PUBLIC INTEREST REVIEW FOR GROUNDWATER APPLICATIONS

TO: Water Rights Section Date August 9, 2016
 FROM: Groundwater Section Aurora C Bouchier
Reviewer's Name
 SUBJECT: Application G- 18286 Supersedes review of na
Date of Review(s)

A. GENERAL INFORMATION: Applicant's Name: Ed Landholding, LLC County: Marion

Water-Level Trends in Nearby Wells

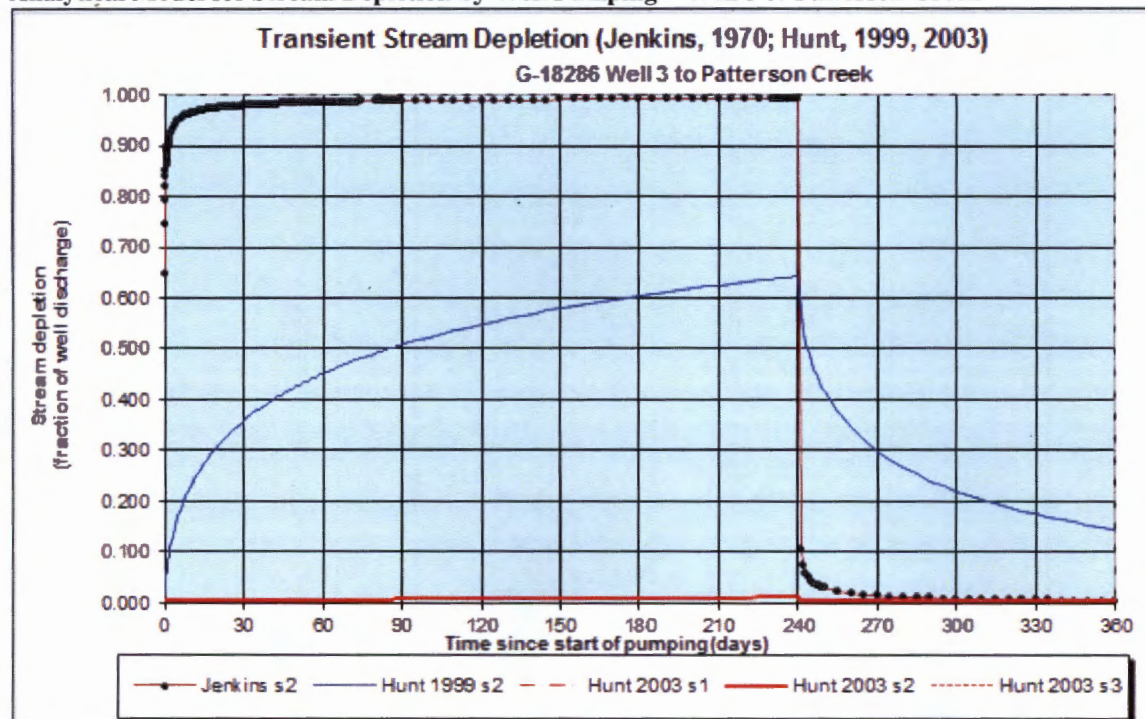
Observations from nearby wells indicate relatively stable long-term trends for alluvial wells in the immediate area of the proposed wells (see attached hydrograph), but increased groundwater development in the area indicates a need for additional water-level monitoring.
